## REVISED RESPONSE TO REQUEST FOR ADDITIONAL INFORMATION

### APR1400 Design Certification

Docket No. 52-046

RAI No.: 44-7877  
SRP Section: 07.04 – Safe Shutdown System  
Application Section: 07.04  
Date of RAI Issue: 06/23/2015

**Figure 7.4-2-1 Non-safety control signals sent from P-CCS to ESF-CCS**

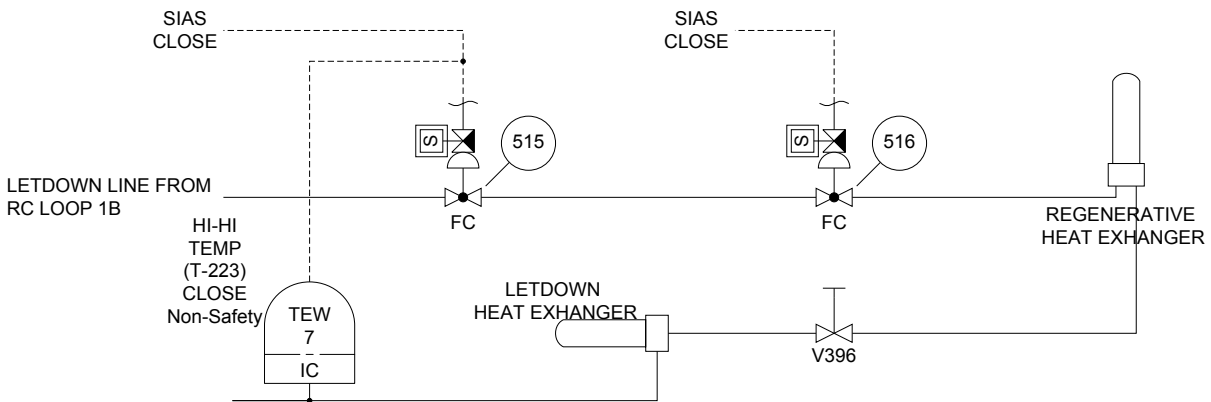
APR1400 FSAR, Tier 2, Section 7.4.1.I, describes how the use fiber optic cables for the MCR/RSR master transfer switches provides the isolation between the Engineered Safety Features - Component Control System (ESF-CCS) divisions and the Process-Component Control System (P-CCS). However, as shown in APR1400 FSAR, Tier 2, Figures 7.4-1 and 7.4-2, the isolation occurs in software switches within the ESF-CCF and the P-CCS.

In addition, the P-CCS sends several control signals to the ESF-CCS. Figure 7.4-2-1 on the page 3 of this response shows a typical example of non-safety control signals sent from P-CCS to ESF-CCS. In this figure, the signals from the non-safety P-CCS for CV-515 are electrically isolated and have communicational independence from the ESF-CCS through the use of isolators between the P-CCS controller and the ESF-CCS controller.

CV-515 is a safety valve and is automatically controlled by an ESFAS signal. The ESF-CCS control logic ensures a non-safety control signal can only close the valve.

Therefore, the non-safety control signal cannot cause spurious opening of the valve at any time.
